Work Order ID 86648

Item ID: D3016-15 Accept *N900040100* Setup Start *NS1*
 Revision ID: Stop *NS2*
 Item Name: Gusset
 Start Date: 7/06/12 Start Qty: 8.00 *8* Cust Item ID:
 Required Date: 7/27/12 Req'd Qty: 8.00 *8* Customer:
 Reference:

DESIGN <i>CP</i>	DRAWN BY <i>CP</i>	DART AEROSPACE LTD HAWKESBURY, ONTARIO, CANADA	
CHECKED <i>#</i>	APPROVED <i>#</i>	DRAWING NO. D3016	REV. A SHEET 1 OF 3
DATE 01.05.18		TITLE SEAT FRAME ASSEMBLY	SCALE NTS
A	01.05.18	NEW ISSUE

DRAWING NO. D3016	TITLE SEAT FRAME ASSEMBLY	REV. A	DART AEROSPACE LTD ENGINEERING ORDER		D.E.O. NO. D3016-A-1	SHEET NO. SHEET 1 OF 1	SCALE NTS
DRAWN <i>1</i>	CHECKED <i>UP</i>	MFG. APPR. <i>RE</i>	APPROVED <i>WAP</i>		DE APPR. <i>#</i>		
DATE 10.01.29	DATE 10.01.29	DATE 10.01.29	DATE 10.01.29		DATE 10.01.29

D3016-11 SADDLE

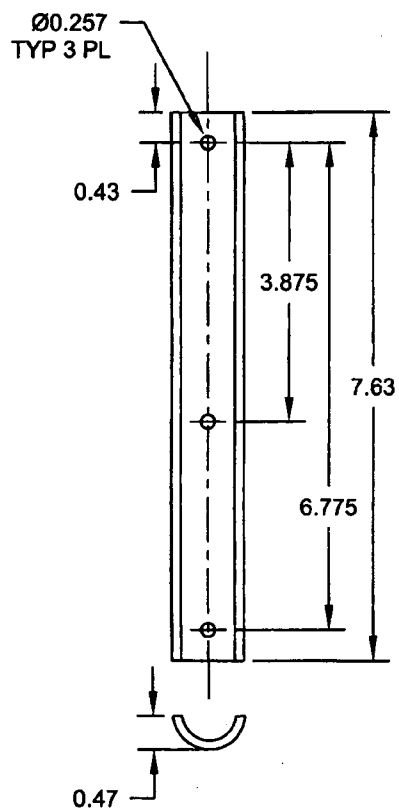
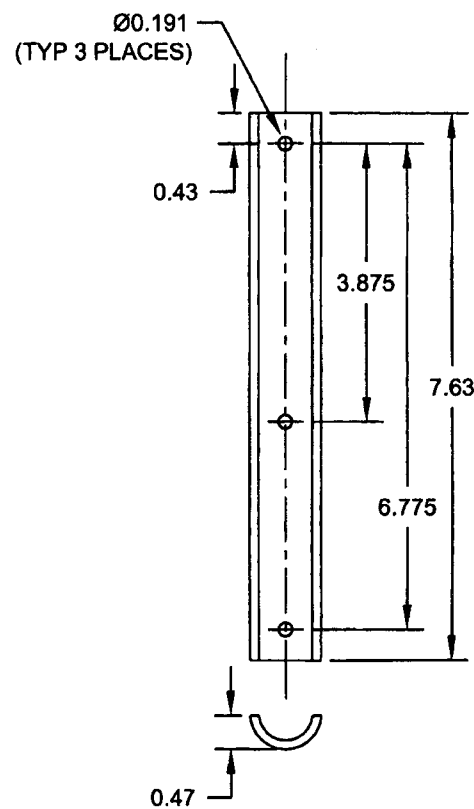
TO REVISE D3016-11 SADDLE'S HOLE SIZES

DETAIL D3016-11 SADDLE (SHEET 3): Ø0.257 TYP 3 PL WAS Ø0.191 (TYP 3 PLACES) AS SHOWN:
